NABCO ENTRANCES TECHNICAL BULLETIN

GT20 Inswing Units with Greater than 0" Reveal Require Two Piece Dog Leg Arm

Bulletin Number: **72**

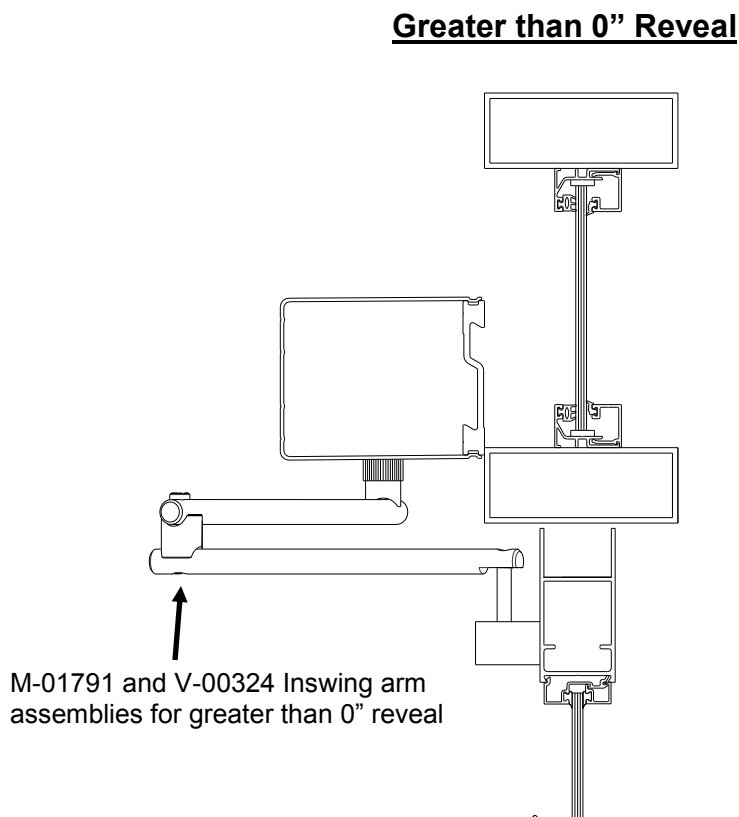
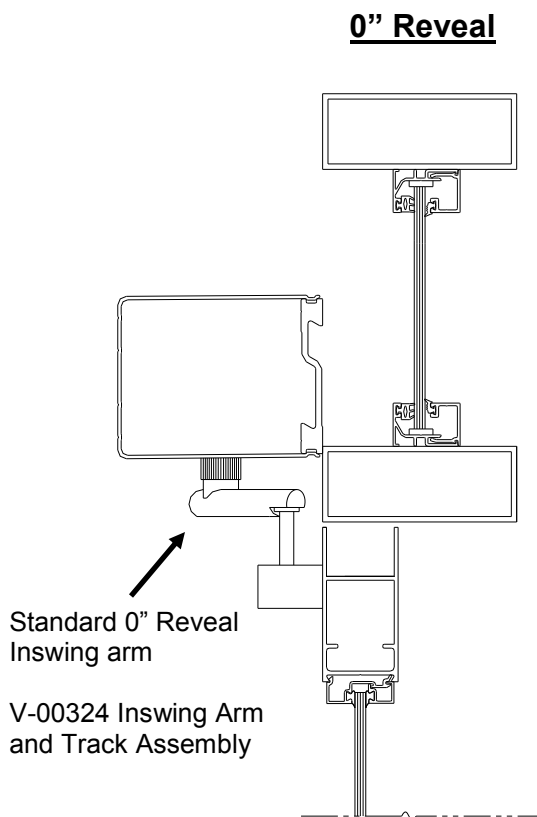
When ordering GT20 inswing units, be aware that the standard inswing arm will only work for 0" reveal. Any greater reveal requires the two piece dog leg arm. When ordering, please specify the reveal and the correct arm so that we can provide you the necessary equipment for your application. This arm configuration is an upgrade to the standard one, please contact customer service for pricing.

The dog leg arm is non-handed. When shipped, it requires the standard arm assembly, V-00324, in addition to the M-01791 assembly to complete the entire assembly. You will receive two arm boxes with the unit.
